## ADMINISTRATIVE AMENDMENT NOTICE

**Petitioner #:** 2011-009

**CIRCLE AT SOUTH PARK**

**SITE PLAN FOR ADMINISTRATIVE REVIEW**

**ADMIN. 1.0**

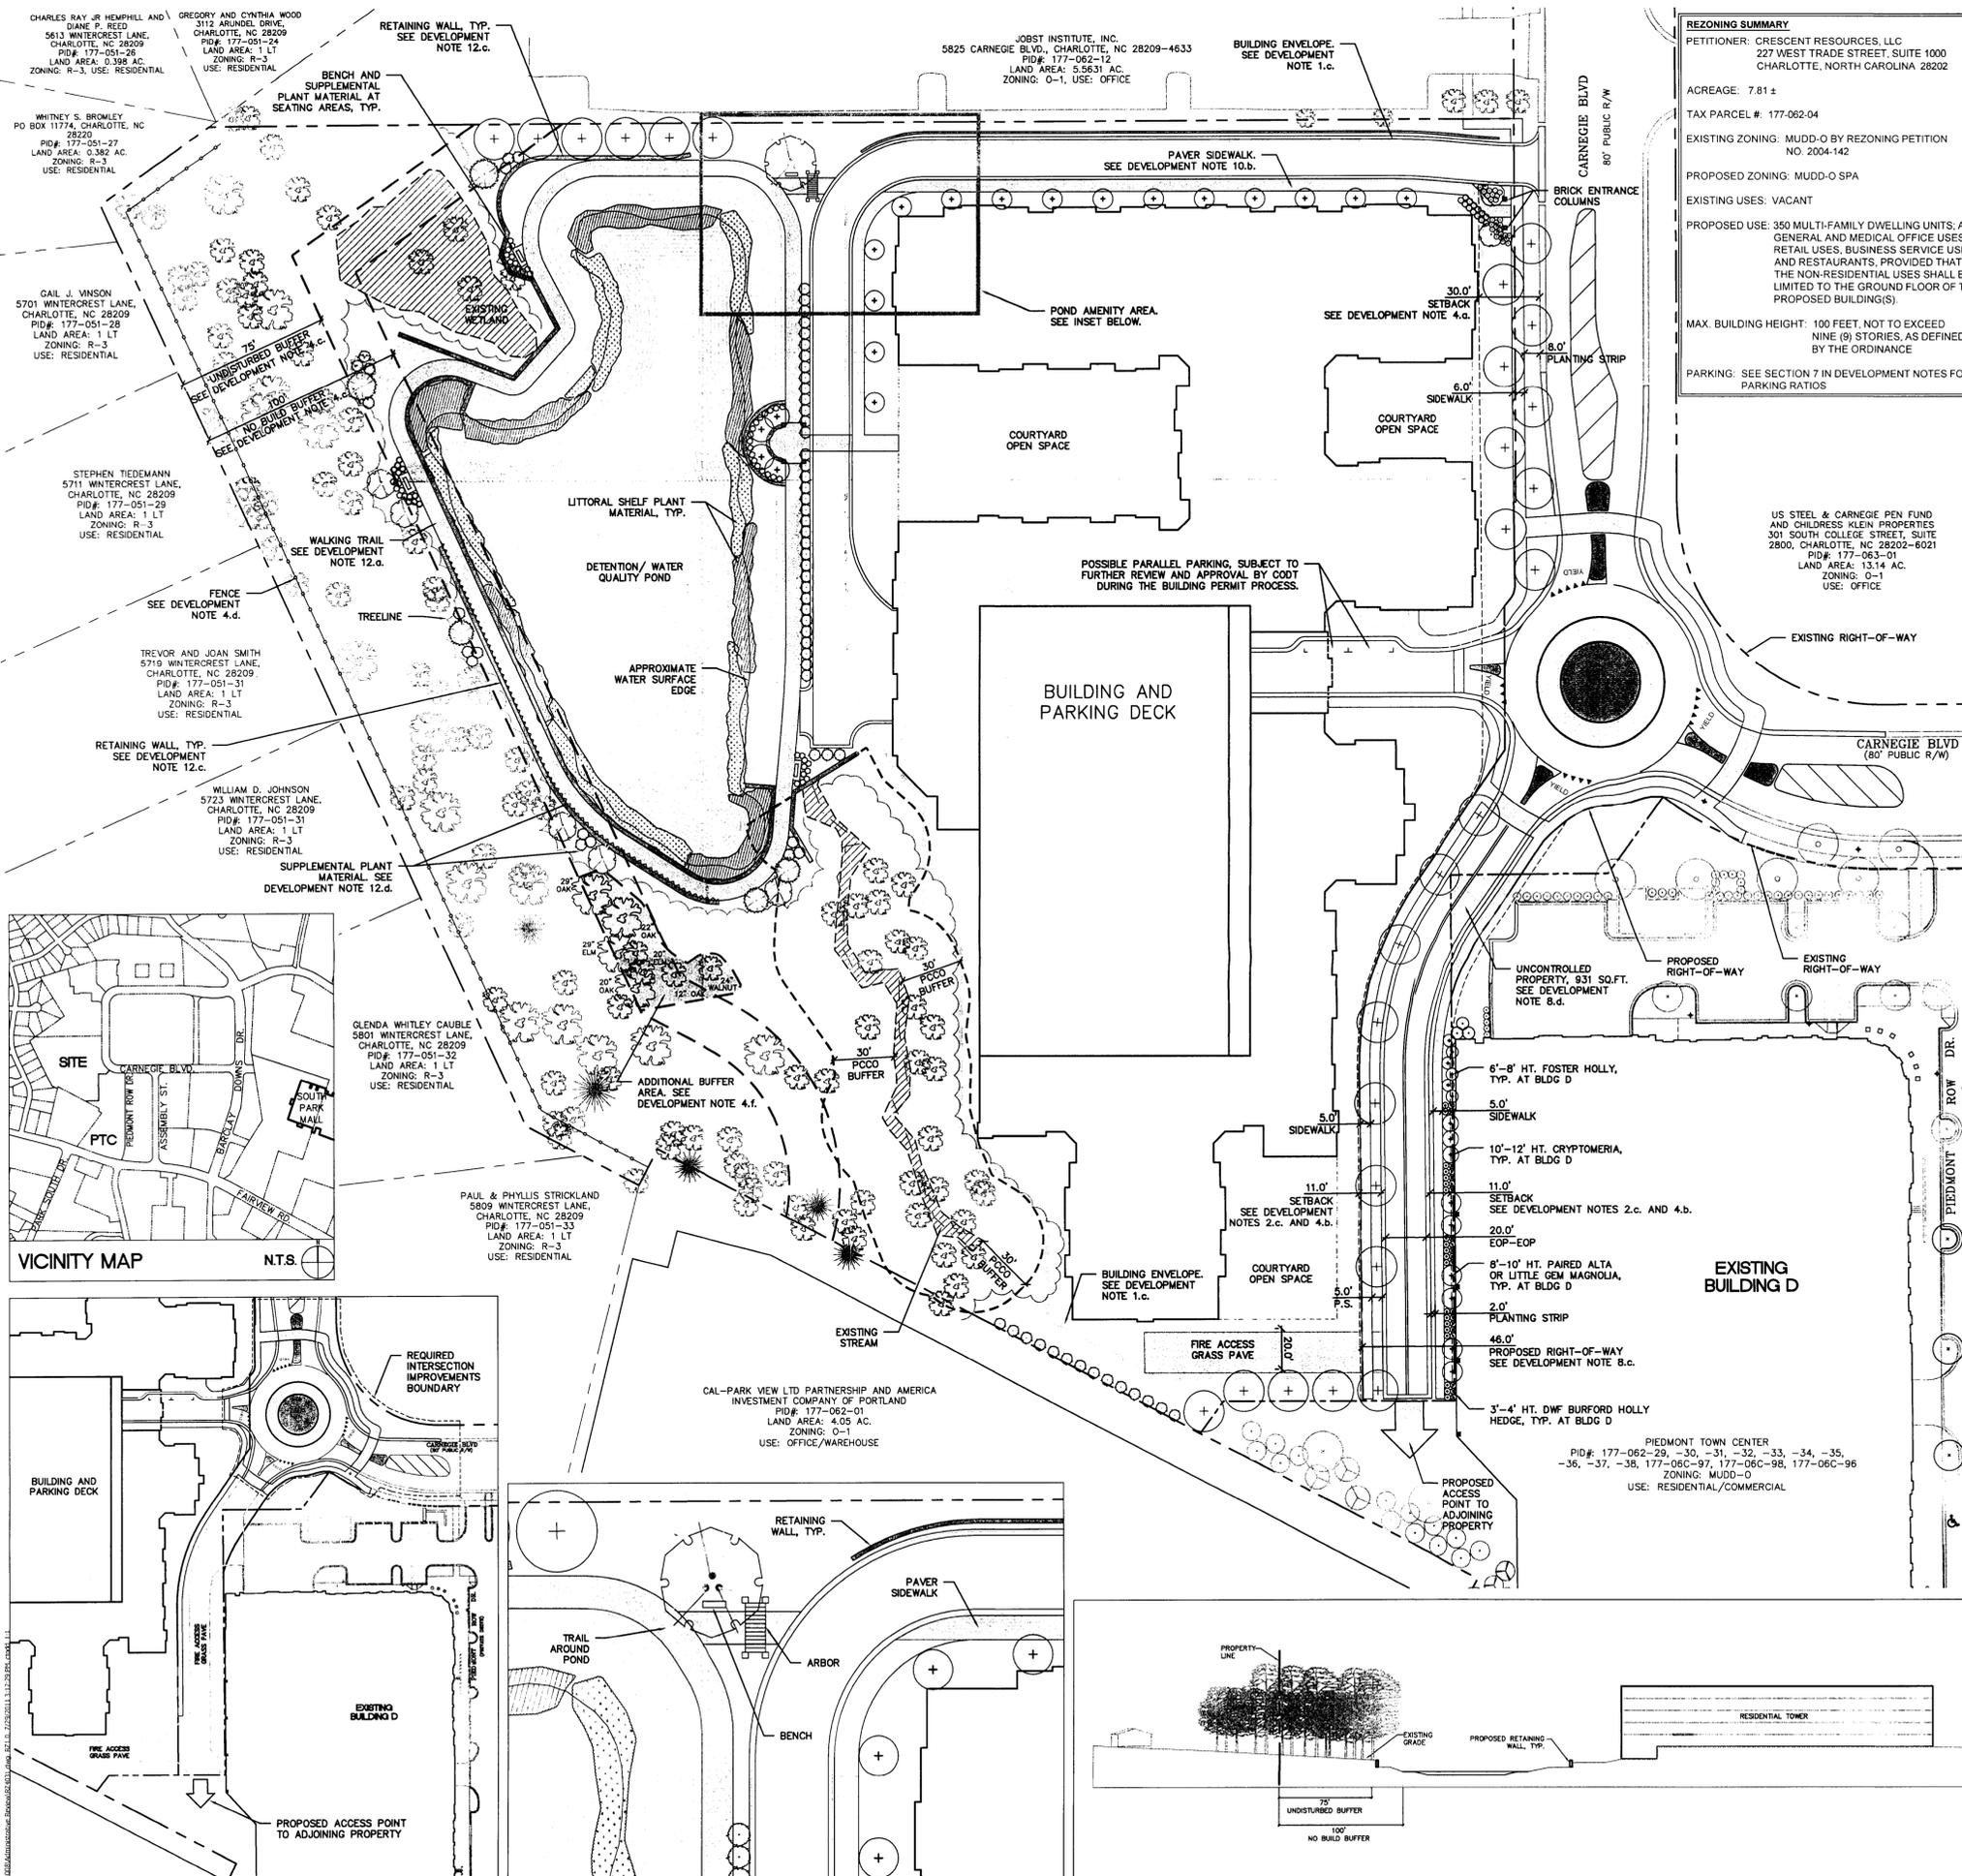
The amendment makes a minor change to the approved Rezoning Petition to *modify the approved site layout*, in accordance with Section 6.207 of the City of Charlotte Zoning Ordinance. Adjacent property owners may appeal the approval of the administrative amendment in writing to the Zoning Committee of the Planning Commission twenty-one days from the date of this notice.

Attached is a revised site plan for the above referenced rezoning petition. The site plan shows the new proposed layout of the site. Since this change does not alter the intent of the development and meets the requirements of the Charlotte Zoning Ordinance Section 6.207 Alterations to Approval, minor changes, I am administratively approving this plan. Please use these plans when evaluating requests for building permits and certificates of occupancy.
